ED-HMI3630-156C

PCN

by EDA Technology Co., Ltd

1 Product Change Notice 1

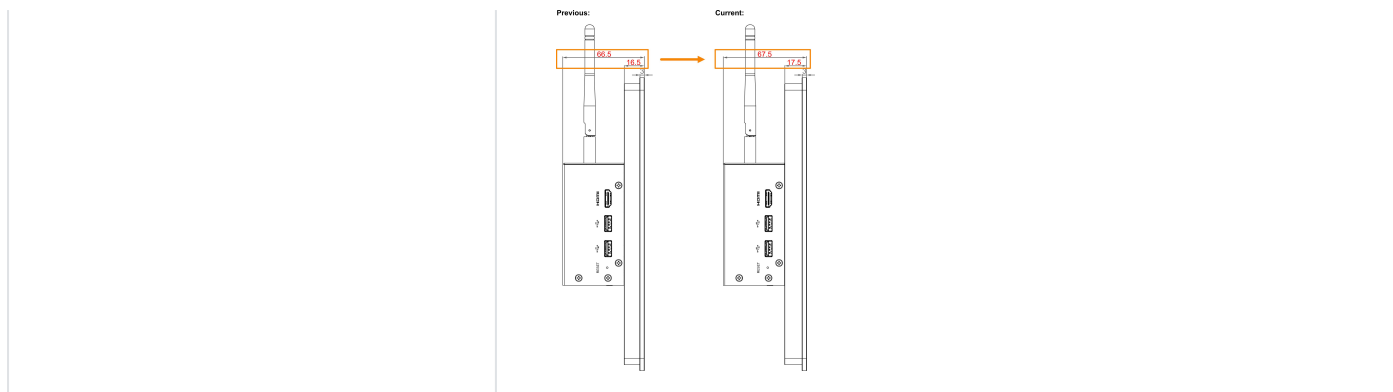
Changes	Results
LCD bezel thickness increased by 1mm	We have optimized the LCD bezel structure to provide additional clearance for internal cable routing. - LCD bezel thickness: adjusted from 16.5mm to 17.5mm. - Total product thickness: correspondingly adjusted from 66.5mm to 67.5mm.
